9026 LAURISTON PL

CERTIFICATE OF COMPLETION/OPERATION PERMIT

MECKLENBURG COUNTY HEALTH DEPARTMENT
SITE EVALUATION REPORT
SERIAL NUMBER 20437

Re: 9026 Lauriston Place
File: 3011A
Parcel: 139-054-27

PLOT OF SYSTEM

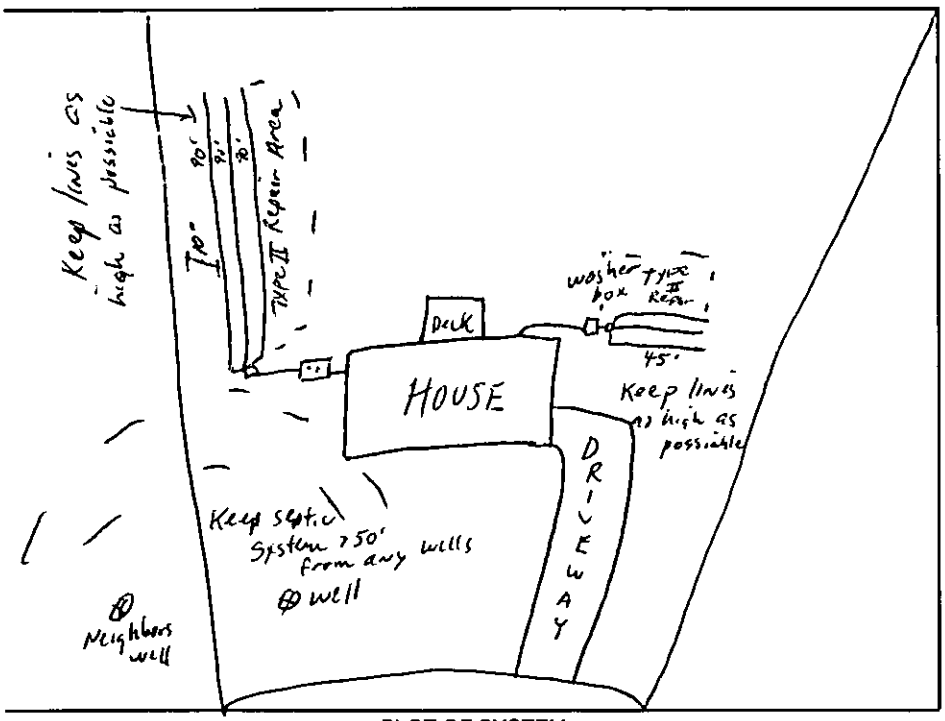
Comments: 1500ST, washer box, Septic 3 lines x 90'long x 3'wd x 12"stone Washer line 3 lines x 45'long x 3'wd x 12"stone | Keep septic system >50' from any wells | Keep lines on contour and high as possible (Pump tank eliminated because of plumbing)

PROPOSED PLOT PLAN

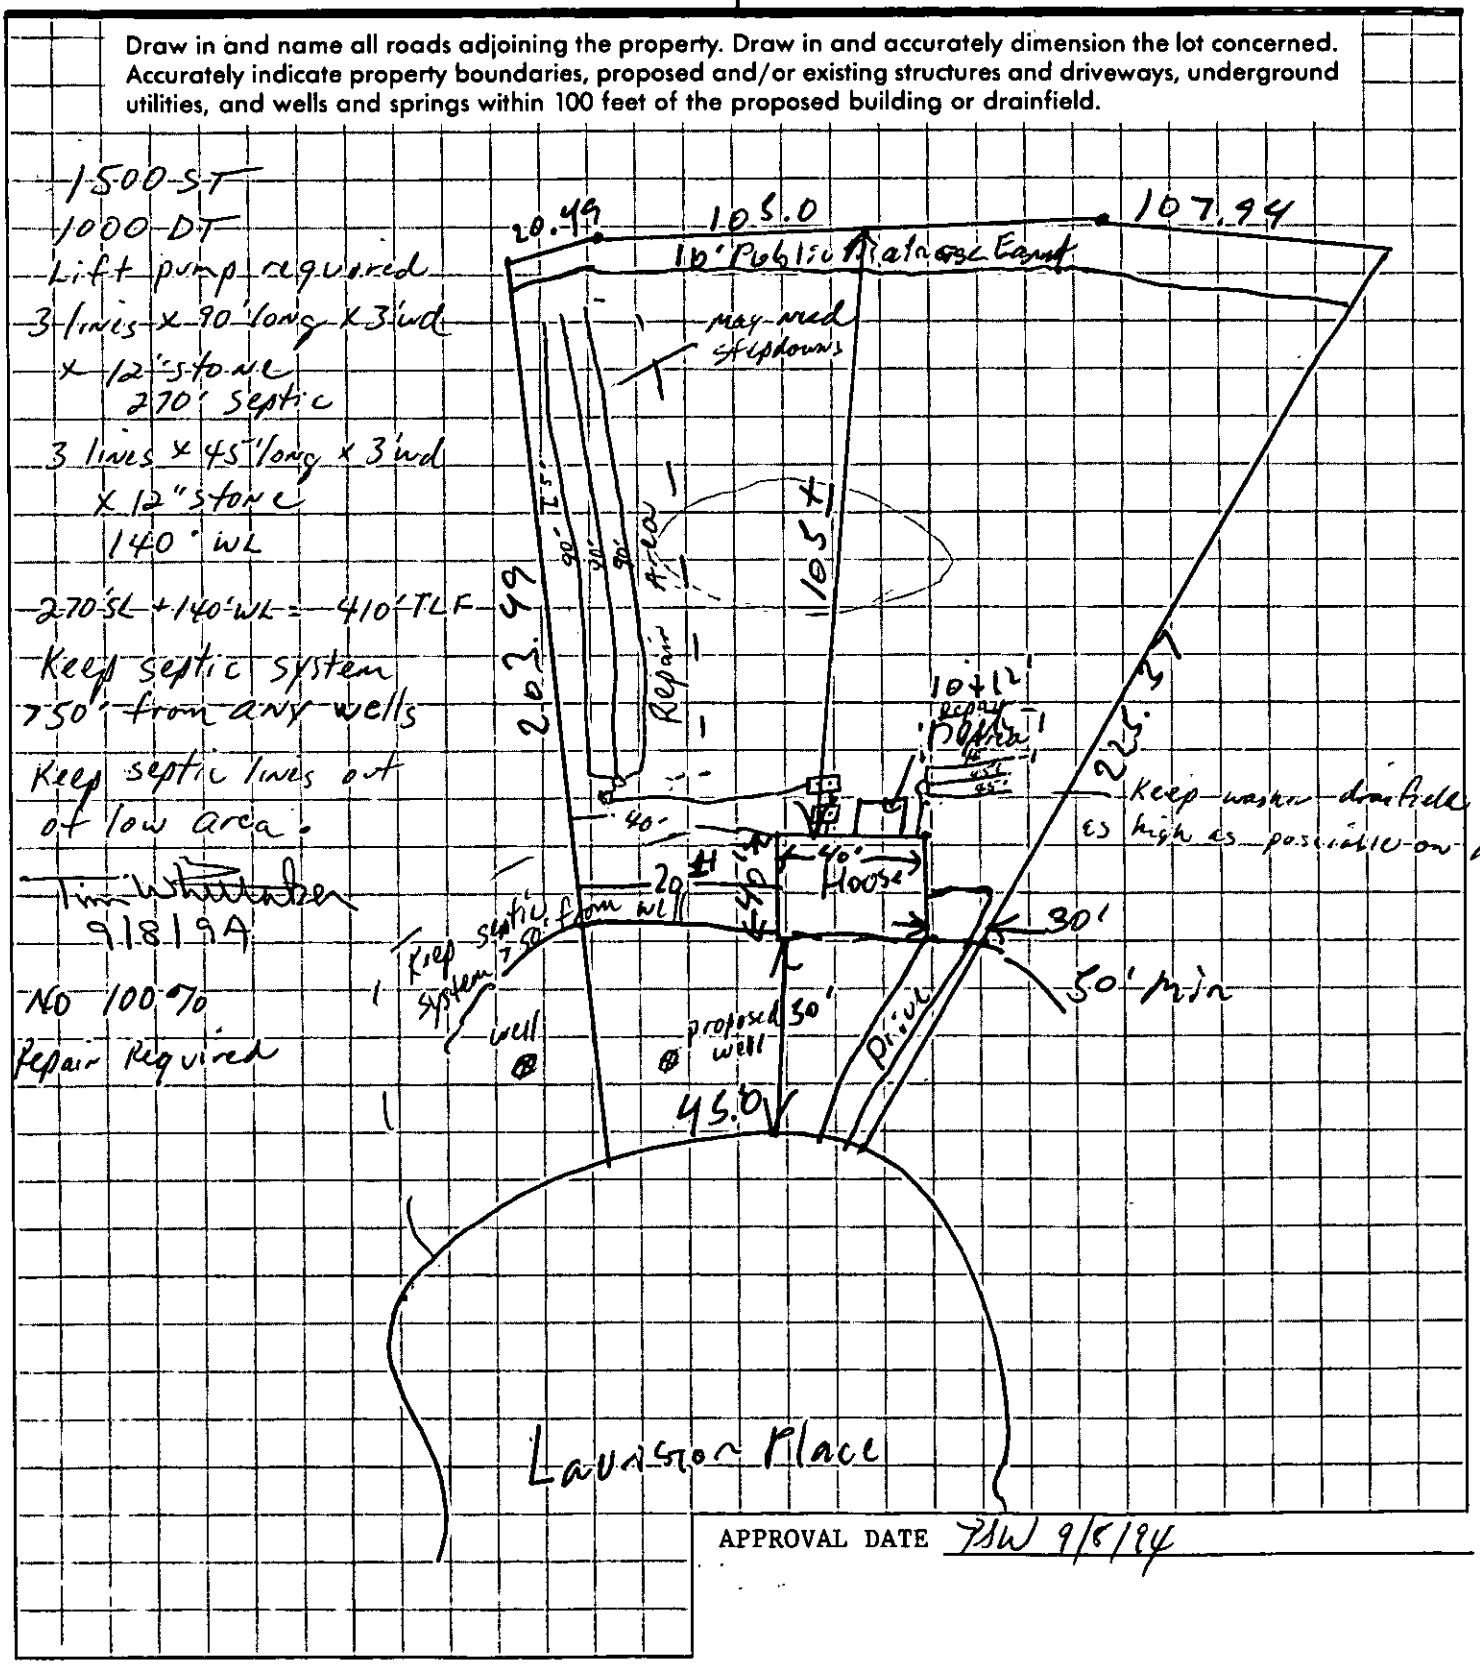
... Lift pump required sufficient area located on higher side of lot (left back portion) and washer line added for system. no 100% required

PROPOSED PLOT PLAN

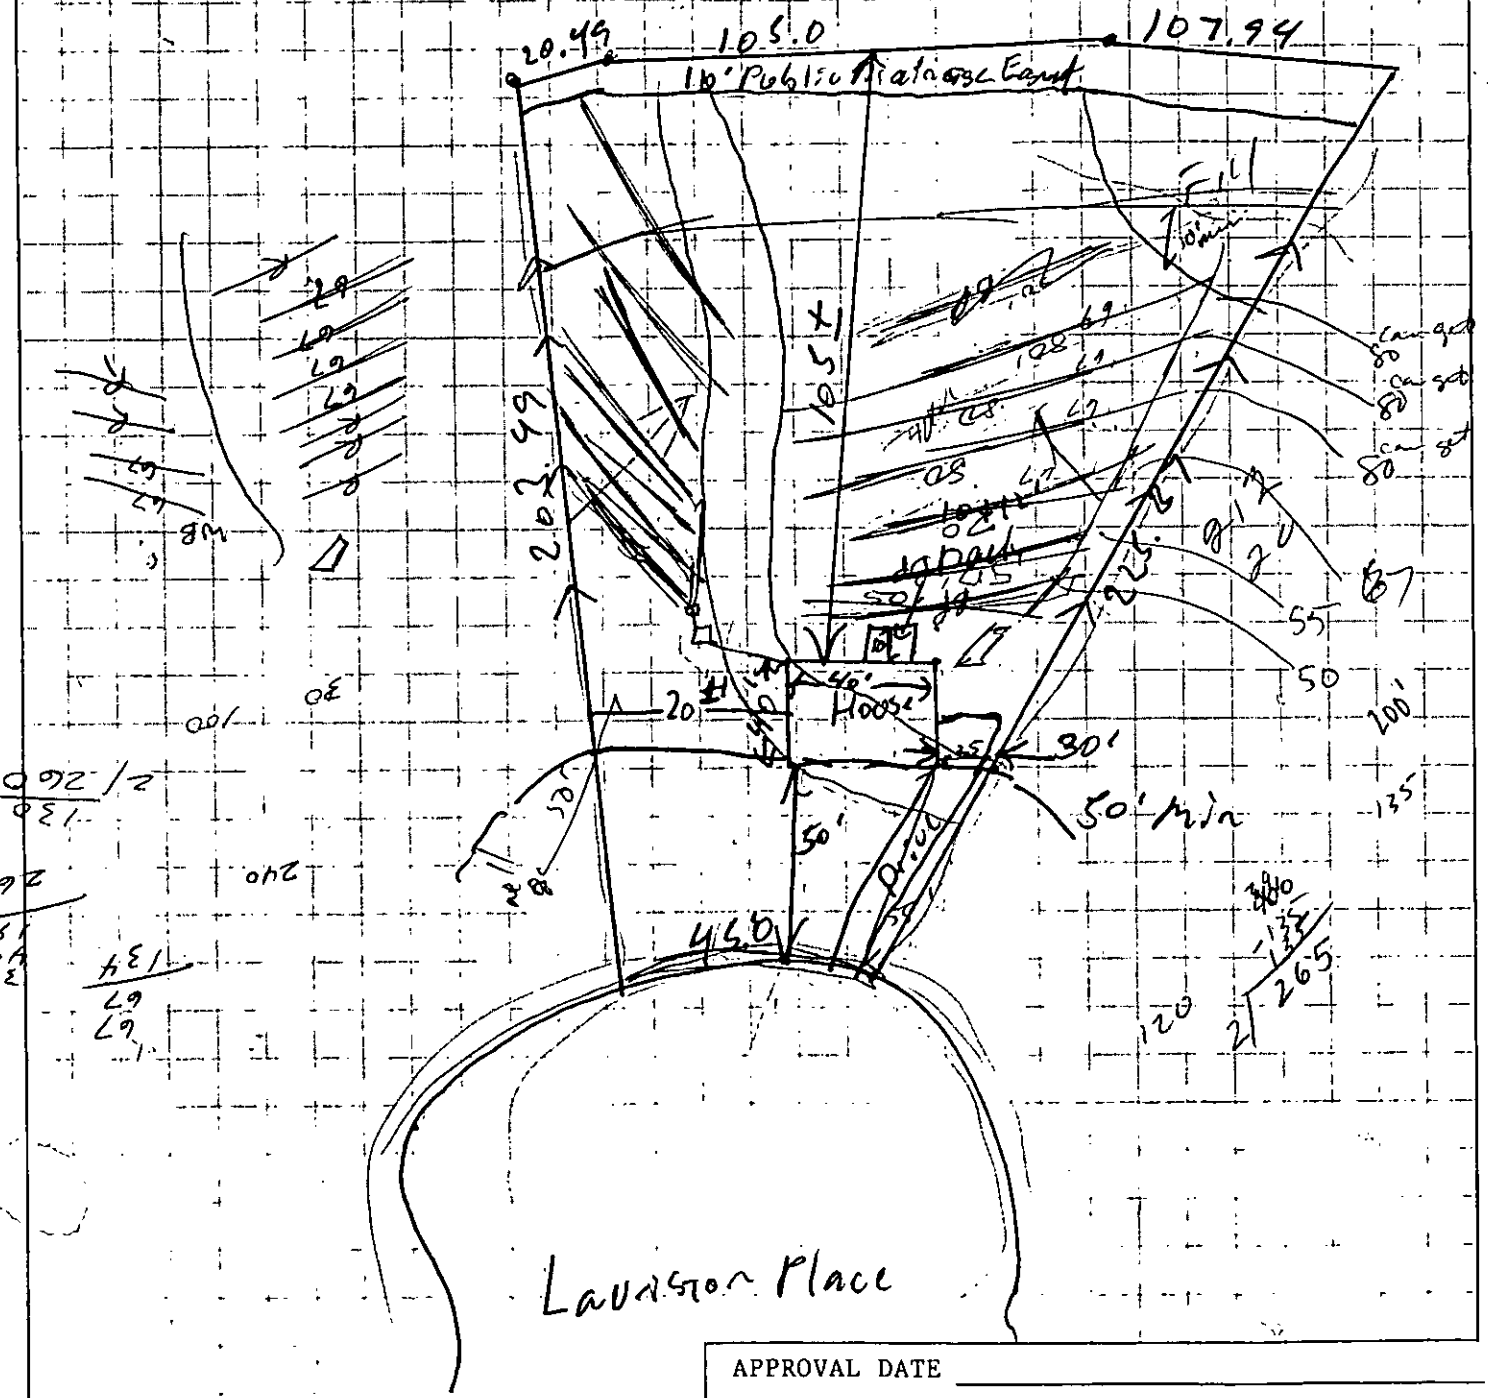
1- The available area on this site is classified as **UNSUITABLE** according to the following rules:
   (a) .1940 Topography and Landscape Position
   (b) .1945 Available Space

For these reasons, the plans as submitted are disapproved.

Possible ways to develop this site includes submittal of a plan for a Prefabricated, Permeable Block Panel System (PPBPS). These plans would also need to include appropriate surface water diversions. Enclosed is a copy of Rule .1956 Modifications to Septic Tank Systems pertaining to PPBP Systems.
